FirstEnergy Nuclear Operating Company

Davis-Besse Nuclear Power Station, Unit 1
Docket No. 50-346, License No. NPF-3
Response to Request for Additional Information Regarding Measurement
Uncertainty Recapture Power Uprate Amendment Application (TAC No.
MD5240)

Response to Request for Additional Information Regarding Measurement
Uncertainty Recapture Power Uprate Amendment Application

Response to Request for Additional Information Regarding Measurement
Uncertainty Recapture Power Uprate Amendment Application
Page 1 of 18

Figure 10 – Measured Velocity Profile for Loop B before and after Loop B transducer replacement (11/27/07 through 12/1/07)

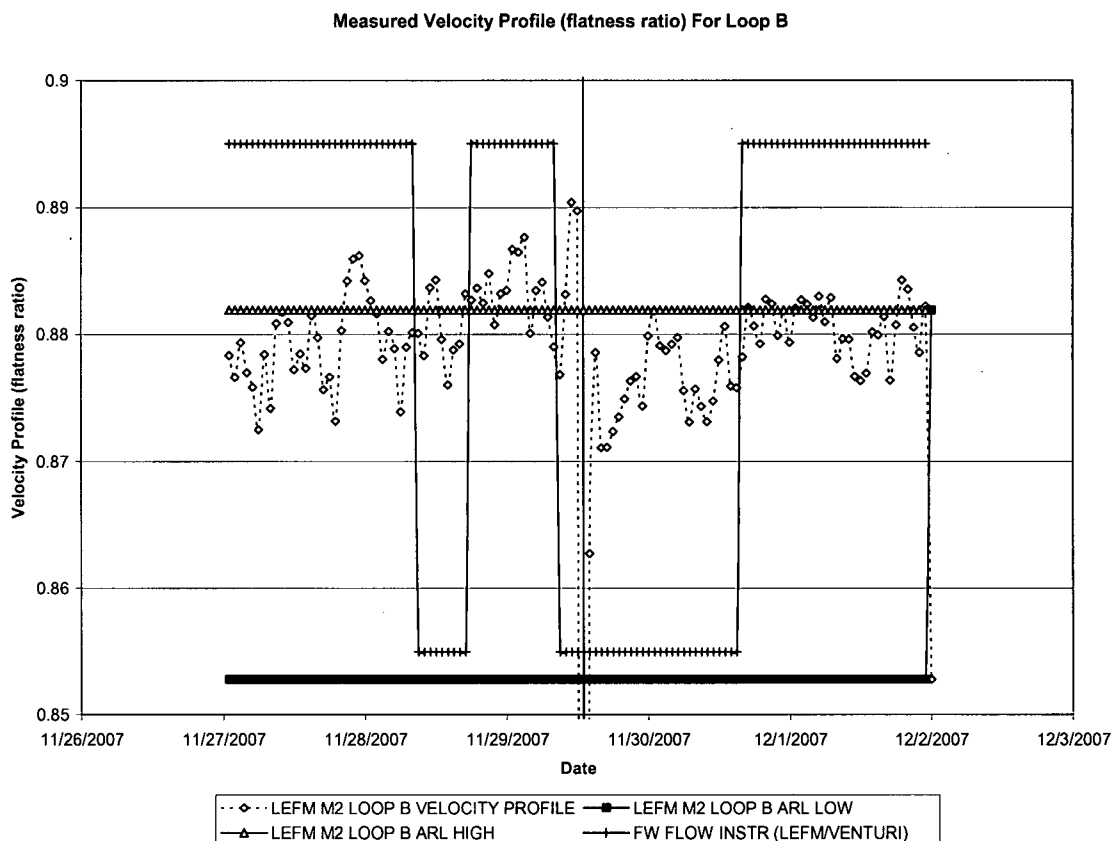
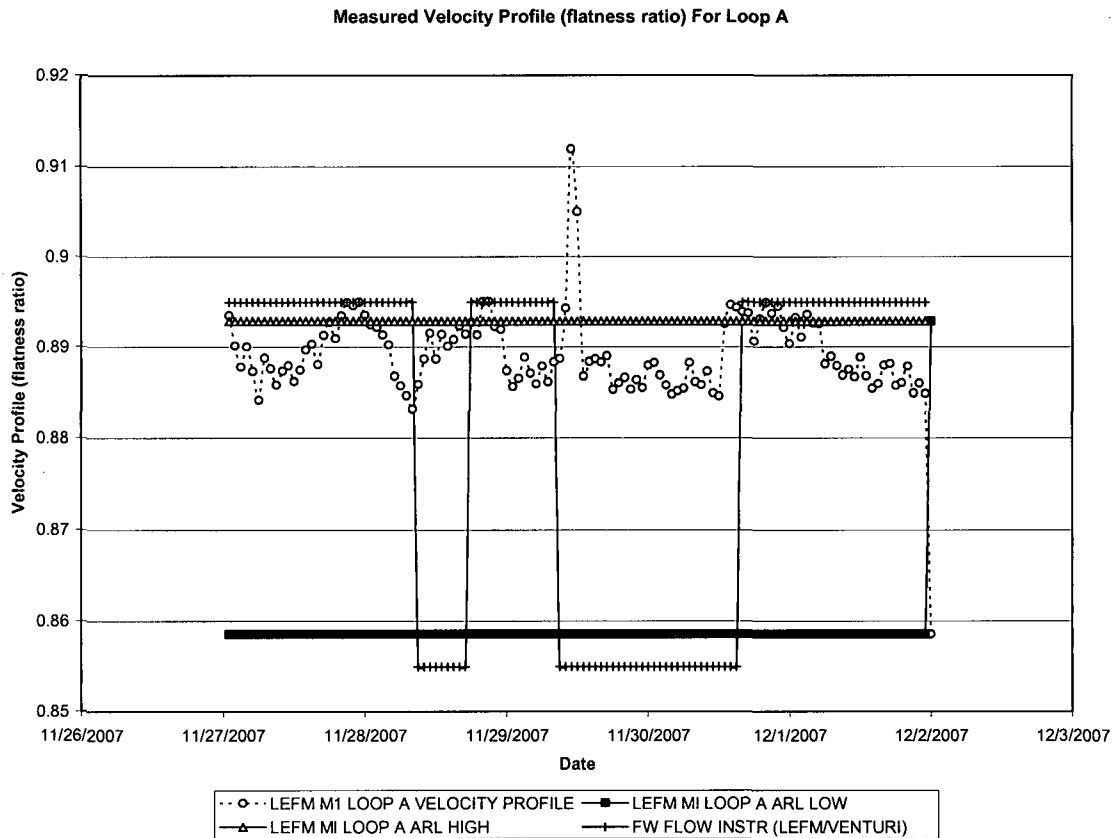
3. Provide flow profile information before and after transducer replacement.

Since the LEFM was placed into service as the heat balance input on April 3, 2007, the transducers were replaced on multiple occasions. It is possible that some changes in measured flatness ratio could be attributed to transducer replacements, but changes in measured flatness ratio do not always occur after transducer replacement. The changes in flatness are small in any event, and are consistent with ER-551 Rev. 1, "LEFM CheckPlus Transducer Installation Sensitivity," which reports the uncertainty associated with transducer replacement. In effect, the changes are within the observational uncertainty of the measurements and consistent with the allowances within the uncertainty analysis.

Figure 10 and Figure 11 display the measured velocity profile before and after transducer replacement on LEFM Loop B in November, 2007. The replacement of the LEFM Loop B transducers resulted in minimal change in flatness ratio. The Loop B approximate average velocity profile before and after transducer

replacement was 0.8791 and 0.8805, respectively. Loop A approximate average velocity profile before and after Loop B transducer replacement was 0.8896 and 0.8895, respectively. As discussed in ER-262, "Effects of Velocity Profile Changes Measured In-Plant on Feedwater Flow Measurement Systems," a real change in flatness ratio would result in a real calibration shift of only $-0.0167\% \times \text{flatness ratio} + 1.0167$. Since the measured flatness ratios shifted, the expected shift in calibration would be approximately -0.01% for Loop B with a very negligible shift in Loop A. These shifts are not discernable measurements and are overwhelmed by normal feedwater system fluctuations. The slight shift in flatness ratio from pre-maintenance levels in Loop B can not be attributed with certainty to the LEFM Loop B transducer replacements or by other combined effects external to the LEFM. The measured velocity profile, as displayed in Figure 10 and Figure 11, overlaps with the profile as determined by the ARL calibration. The span of the velocity profile for the meter installed in the plant is within the span of profile tested in the ARL calibration, before and after the transducer replacement. Therefore, there is confidence that the accuracy of the LEFM is not compromised by a replacement of the transducers.

**Figure 12 – Measured LEFM Flow vs. Venturi Flow (MPPH)
from 4/3/07 through 12/26/07.**

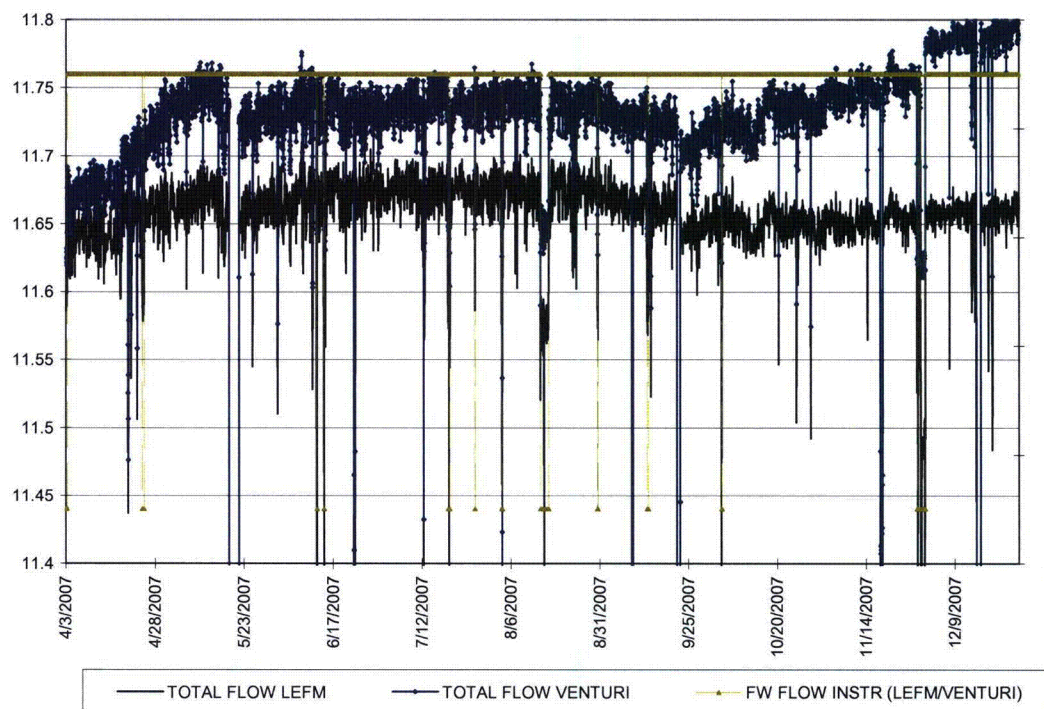
4. Provide assessment of how transducer replacement and operating history changes affected calibration.

The response to Question 1 contains Figures 1 and 2. Figure 12 contains a sample of data comparing LEFM and venturi flow outputs through the same time period as identified in Figures 1 and 2 and encompasses several separate transducer replacements. In Figure 12, there is a notable shift in the venturi flow rate when compared to the LEFM flow, particularly, after the November 29, 2007 transducer replacement. As discussed in ER-262, "Effects of Velocity Profile Changes Measured In-Plant on Feedwater Flow Measurement Systems," a real change in flatness ratio would result in a real calibration shift of only $-0.0167\% \times \text{flatness ratio} + 1.0167$. The indications in Figures 1 and 2 are consistent with these results. Also, as identified in the response to Question 3,

the flatness ratio resulting from the replacement of Loop B transducers on November 29, 2007, slightly shifted the measured flatness ratio on Loop B. The expected shift in calibration would be approximately -0.01% for Loop B. Additionally, there was a very negligible shift in Loop A. These shifts are not discernable measurements and are overwhelmed by normal feedwater fluctuations. The slight shift in flatness ratio from pre-maintenance levels in Loop B can not be attributed with certainty to the LEFM Loop B transducer replacements or to other combined effects external to the LEFM. Therefore, it can not be determined with certainty what portions of the deviation in venturi flow can be attributed to the transducer replacement or to other combined effects external to the LEFM, such as changes in valve positions, feedwater heater efficiencies, pump speeds and neutron flux distribution in the core. The separation between the LEFM flow rates and the venturi flow rates, beginning in early November, 2007, can be attributed to fouling of the venturis, which is a well-documented occurrence within the industry.

Figure 13 – LEFM Flow Versus Low Pressure (LP) Condenser Pressure and First Stage Pressure

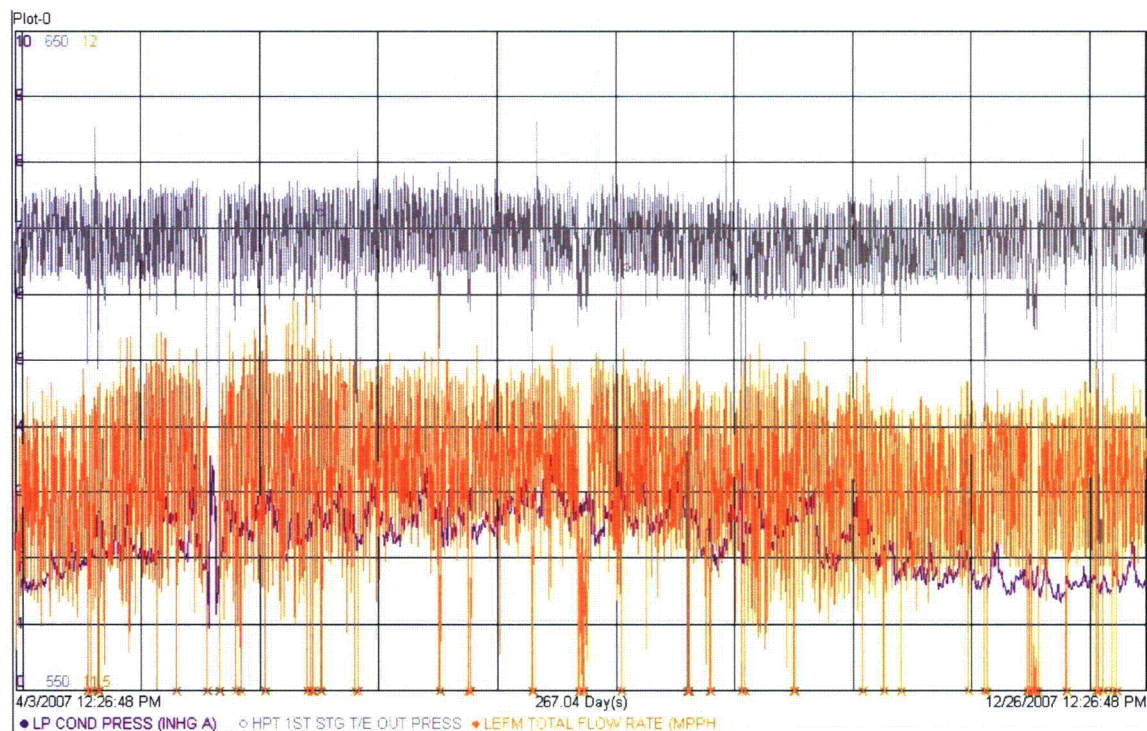
6. With respect to Items 1 – 5 above, provide comparison with other plant parameters that vary with power level behavior. The intent is to examine confirmation of CheckPlus indication by use of other plant information.

In Figure 13, the LEFM flow is scaled vertically between 11 and 12 millions pounds mass per hour (MPPH), turbine first stage pressure scaled between 550 and 650 psig, and condenser pressure is scaled between 0 and 10 inches mercury absolute with reactor power relatively constant over the specific time period. The exceptions to maintaining a constant 100% power were primarily due to various equipment issues, maintenance, or surveillance instruction performance. Additionally, the LEFM was removed from service on several instances to support various maintenance and repairs.

Comparing the LEFM flow value to the first stage pressure and condenser pressure can identify adverse trends in secondary plant performance. The trends in Figure 13 display the LEFM flow and the condenser pressure following each other. First stage pressure follows the inverse of condenser pressure due to overall plant efficiency increasing and decreasing with condenser pressure. These three parameters display the overall plant response as being consistent with changing conditions.
